# Review of the Seabrook Units 1 and 2 Auxiliary Feedwater System Reliability Analysis

Prepared by A. Fresco, R. Youngblood, I. A. Papazoglou

Brookhaven National Laboratory

Manuscript Completed: October 1983  
Date Published: February 1984

Figure 2: Seabrook Nuclear Station  
Startup Feed Pump System

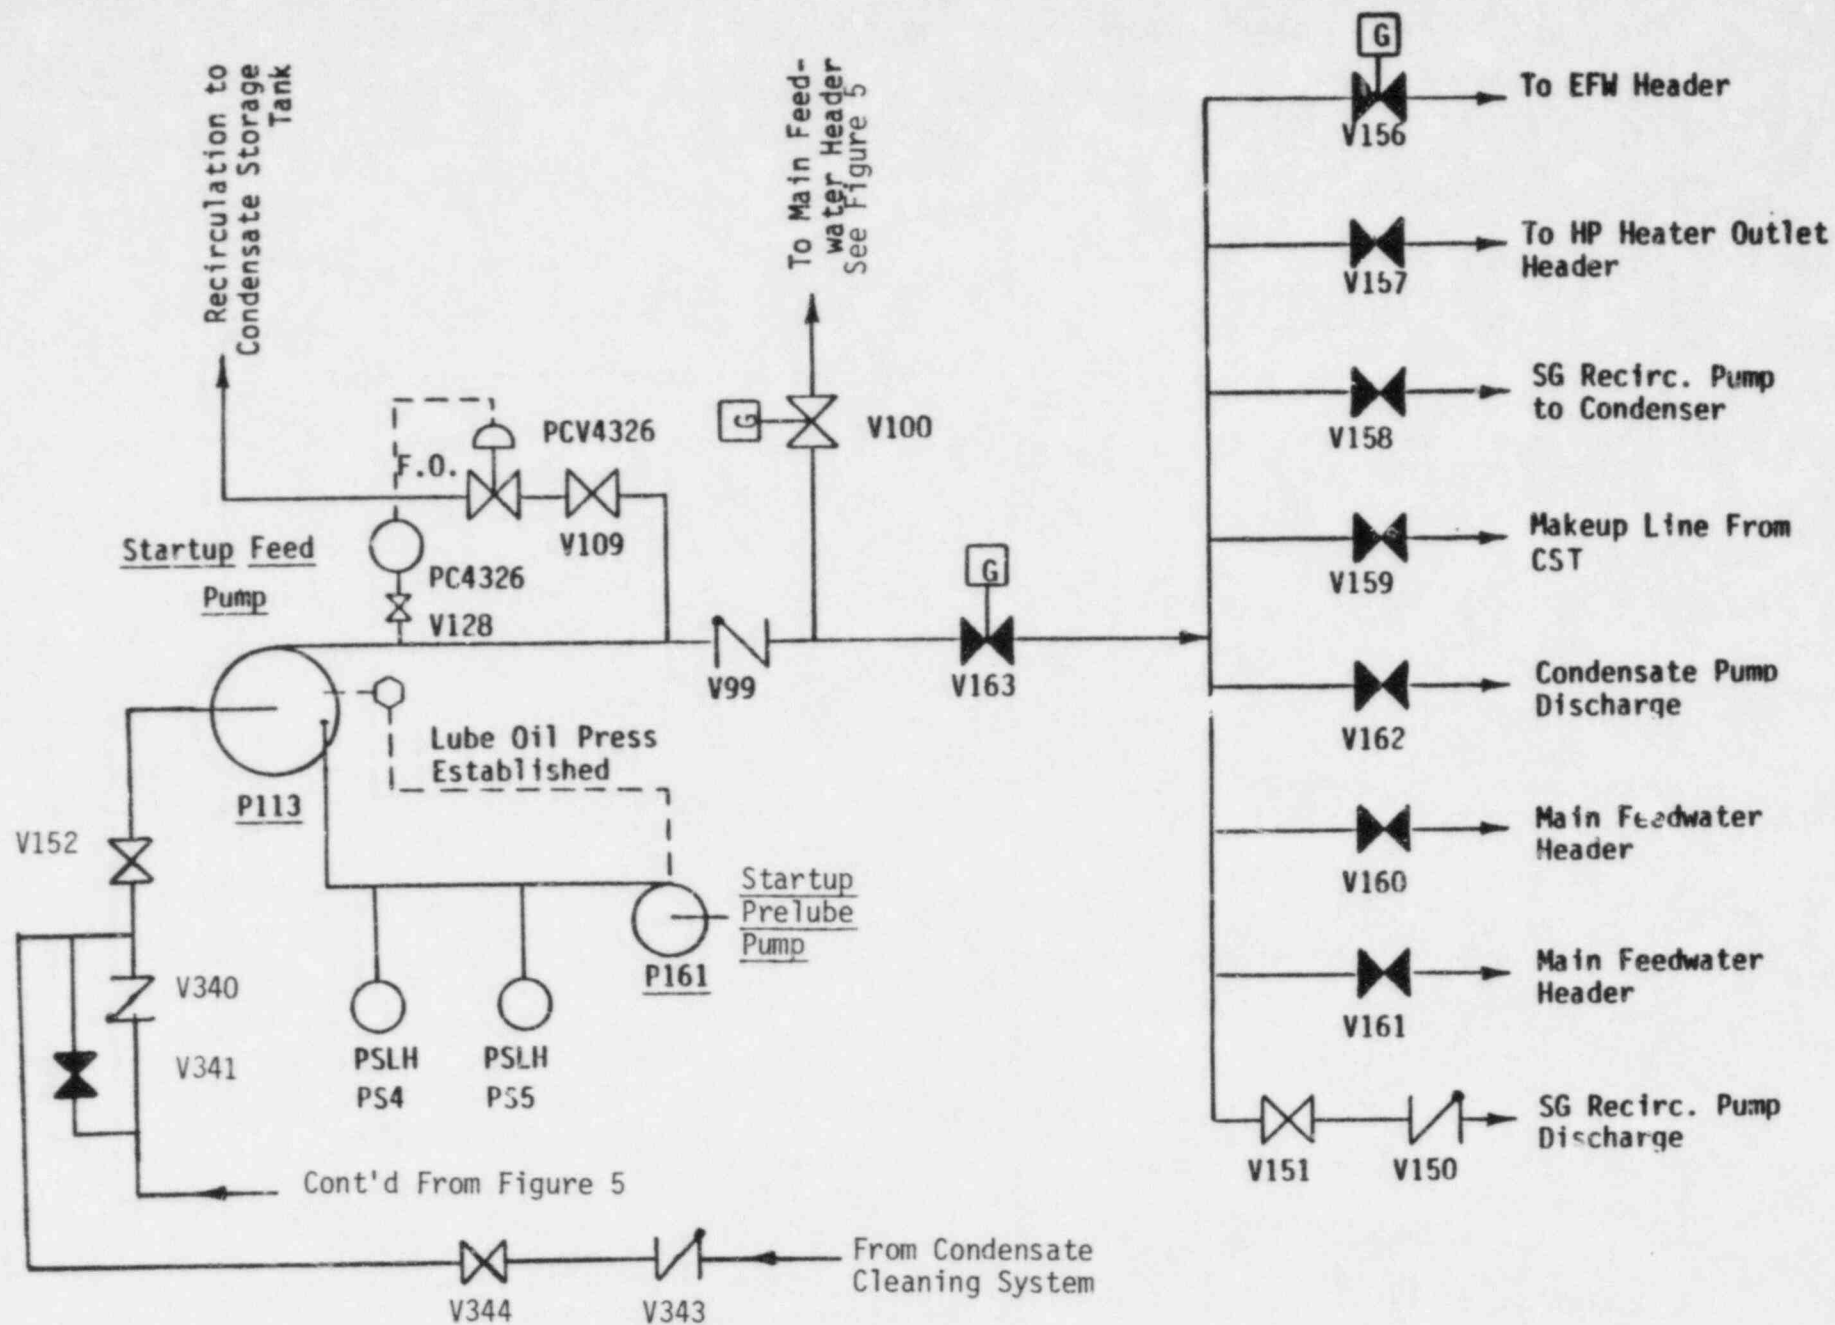
BNL Comment: The exception referred to above is the supposed necessity of closing V-109 which isolates the SUFP recirculation line to the Condensate Storage Tank before the SUFP has been aligned to the EFW header. RFF.3 states that this local manual operator action is required to prevent diversion of flow from the SUFPS because a LOOP could result in PCV-4326 opening due to loss of air supply. However, in the September 7, 1982 letter (Appendix D), the applicant states that even if the recirculation line to the CST remains open, the maximum recirculation flow rate possible is insufficient to cause a reduction in the SUFP flow capacity to a level at which mission success is jeopardized. Since the SUFP normal flow capacity is 1500 gpm, while each EFW pump has a capacity of 710 gpm and only one of the EFW pumps is required to achieve a flow rate sufficient for mission success, BNL agrees that flow through the SUFP recirculation line cannot cause insufficient flow from the SUFP.

BNL Comment: As discussed previously, it is not necessary to close V-109, the SUFP recirculation line isolation valve, for either the previous or proposed designs. BNL assumes that more than one operator would be required to perform the valve manipulations because V-156 is located in the EFW pump area, which is a considerable distance from the SUFP, located in

Figure 3: Seabrook Nuclear Station Emergency Feedwater System

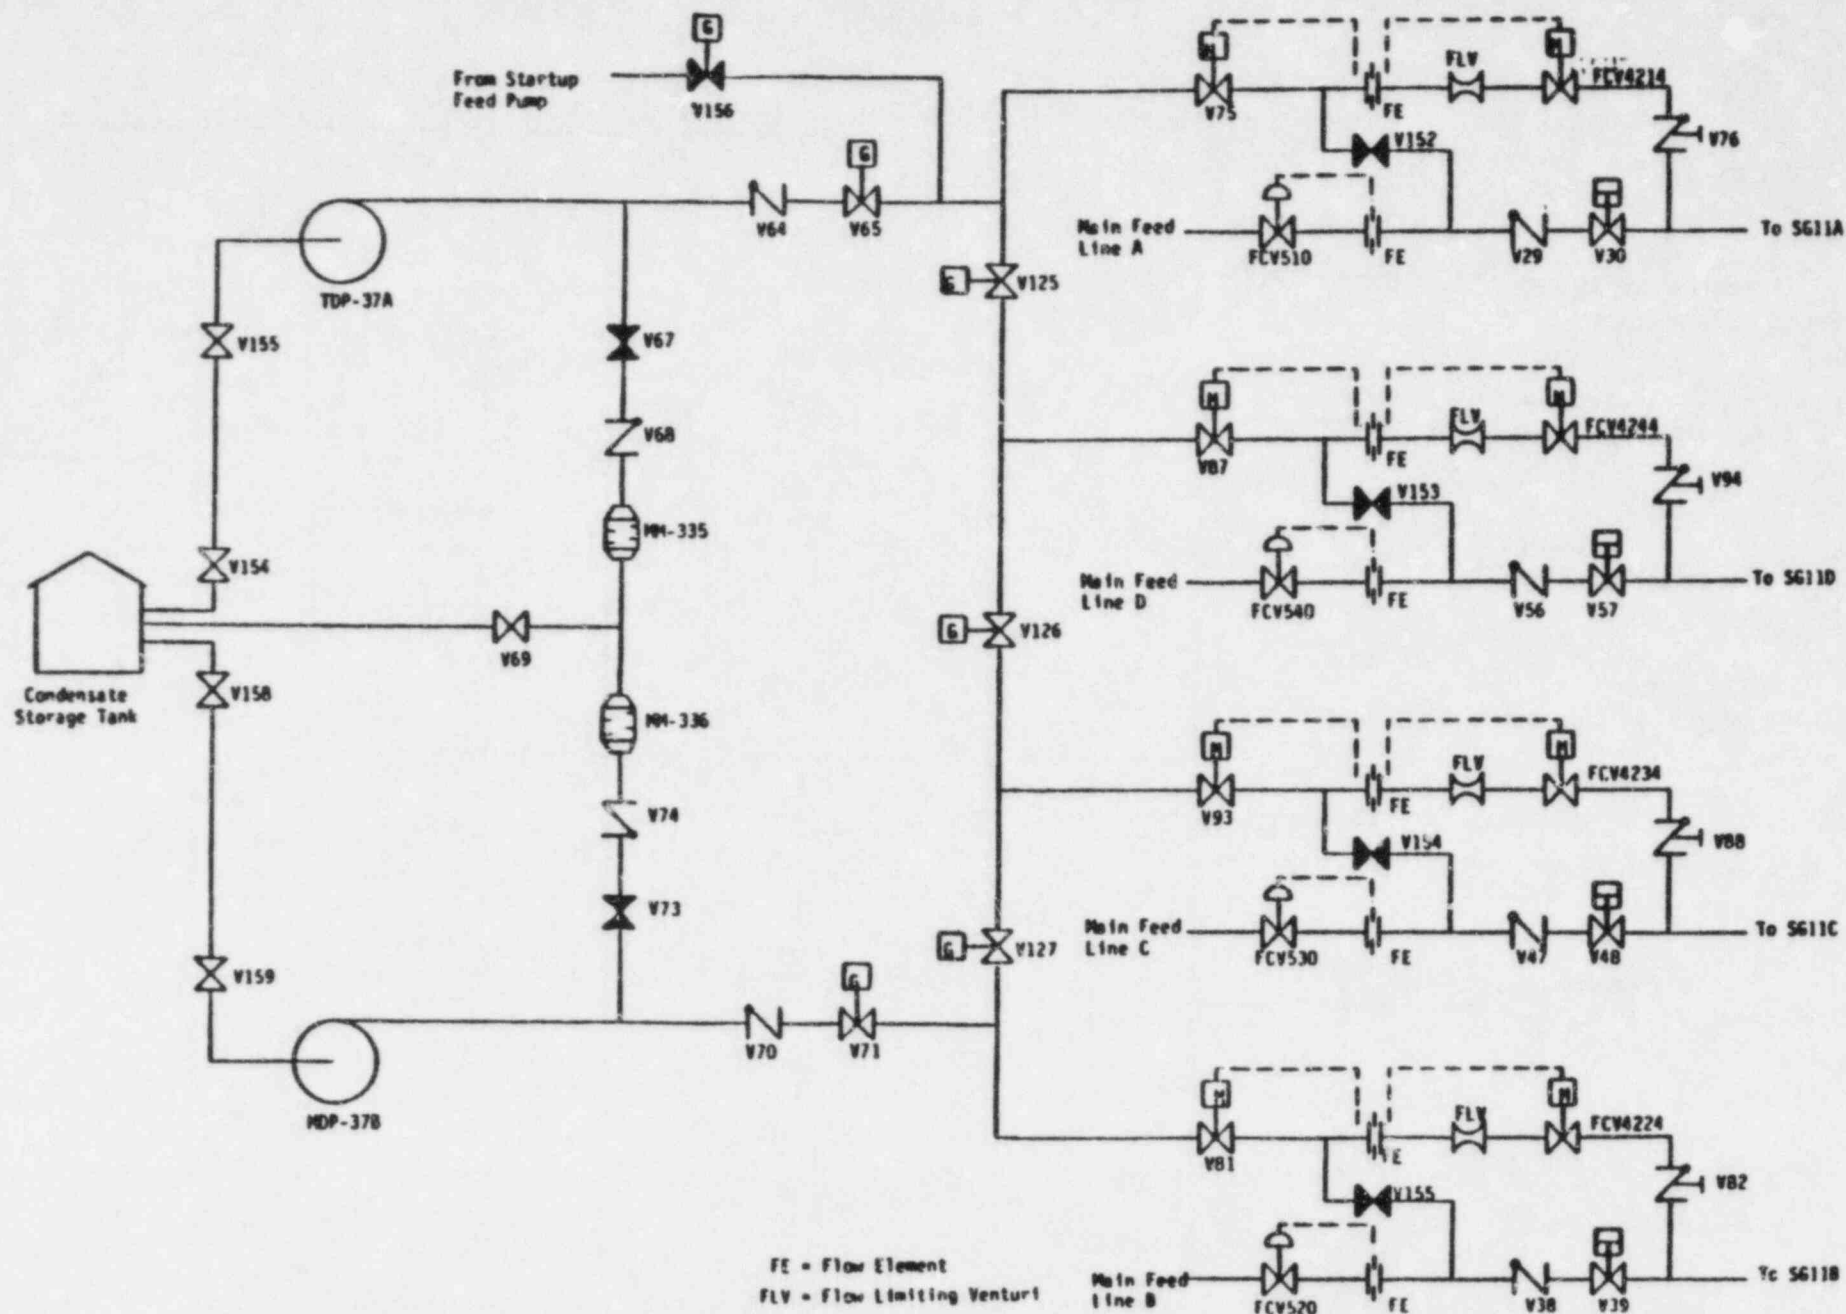
BNL Comment: At the June 23, 1982 meeting at the NRC offices, the applicant stated that the maximum flow through the recirculation lines is 220 gpm. There is no recirculation during the normal operation of the EFWS. The recirculation lines are used for pump testing. The pump performance at 220 gpm is matched against the manufacturer's performance curve for the TDH at 220 gpm. Any deviations would be noted. There are no provisions for full flow pump testing.

BNL Comment: At the July 15, 1982 plant visit, the applicant stated that the CST has a design capacity of 400,000 gallons and that under virtually all plant conditions, the normal level would be this amount. Of the 400,000 gallons, 200,000 gallons is reserved for the EFWS. The connec-

tions for the EFWS are at the base of the CST. The SUFP normally draws water from a connection on the main condensate make-up line which is connected to the CST above the 200,000 gallon level. However, the SUFP can also draw water from the base of the CST through a normally closed, locked valve. This is not shown on Figure 3.

Figure 4: Steam Supply for Turbine-Driven EFW Pump

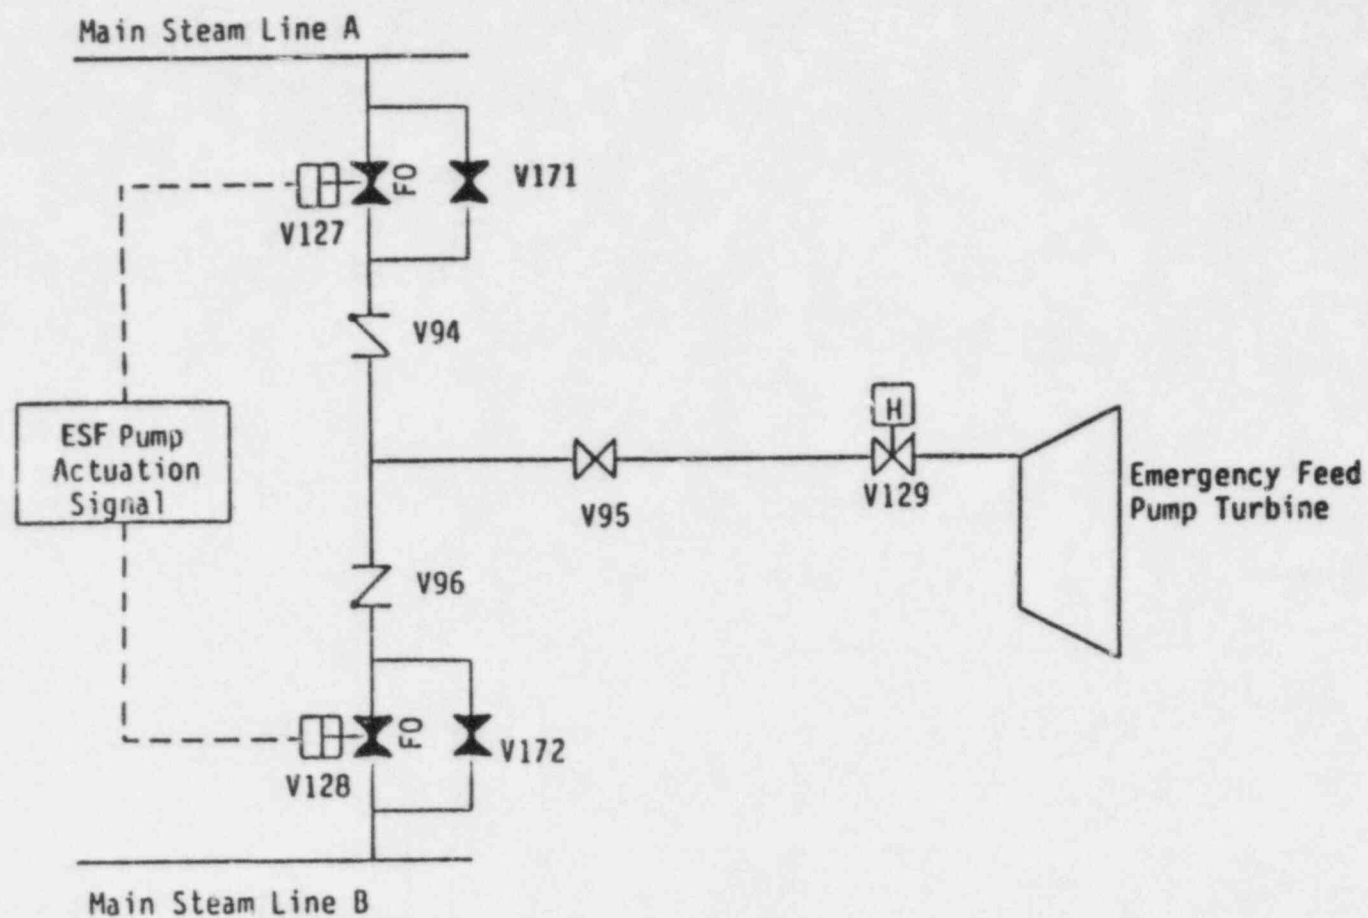
In one other situation, BNL has revised the fault trees to indicate that if maintenance on one of the steam supply valves, V-127 or V-128, is to be performed, then the other valve must also be closed (see Figure 4). It was deemed unreasonable to assume that maintenance could be performed on active main steam lines without taking such actions. The net effect is that a maintenance act on one of those valves causes the pump, TDP-37A, to be unavailable.

Figure 1: Comparison of Reliability of Seabrook AFWS to Other AFWS Designs in Plants Using the Westinghouse NSSS.

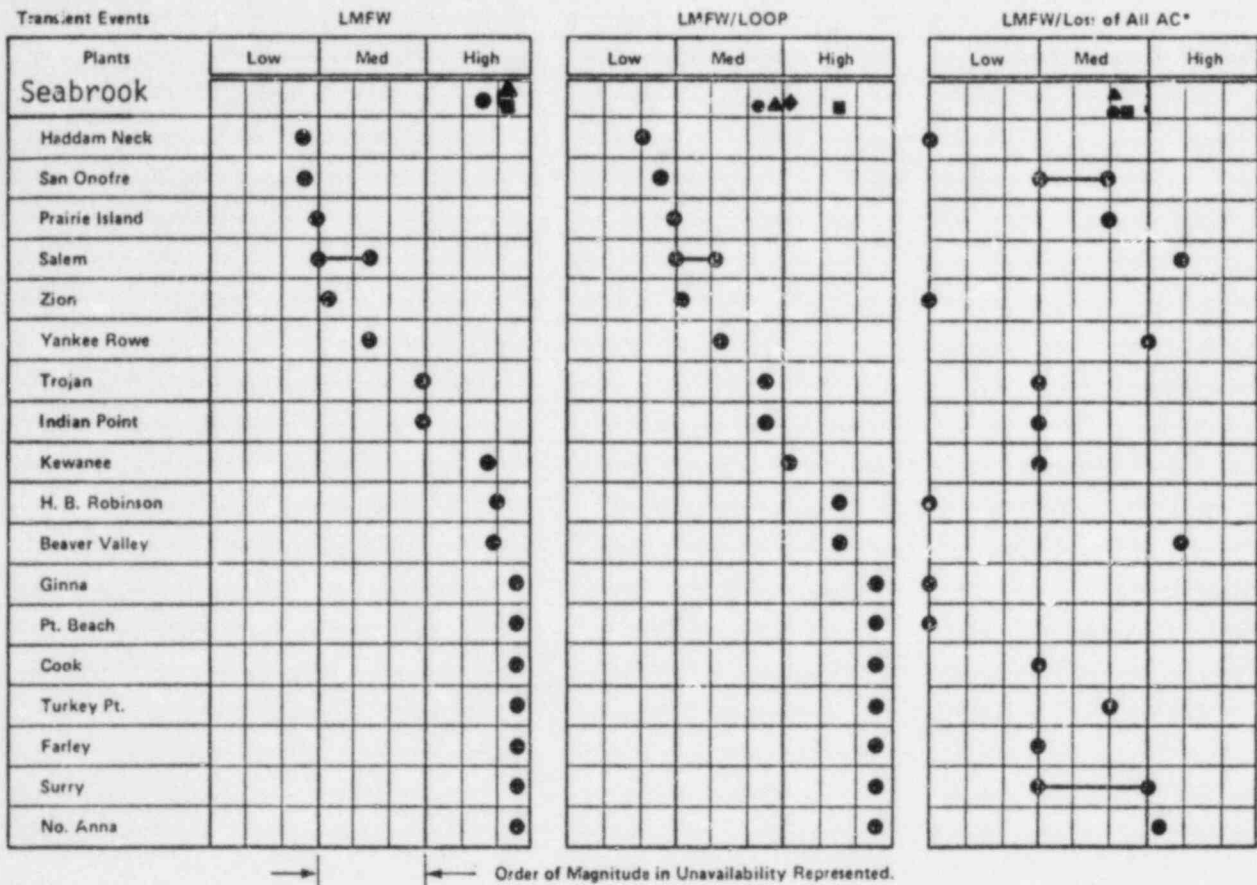
In addition, the capability would remain to open valves V-163 and V-156, which will now be motor-operated from the Control Room, to allow the SUFP to supply feedwater through the EFW header. Thus, the result obtained of  $8.6 \times 10^{-5}$  will not be significantly affected by the unavailability of the MFW flowpaths. Revised copies of Figure 11, Sheet 3, Table 11, and Figure 1 are attached.
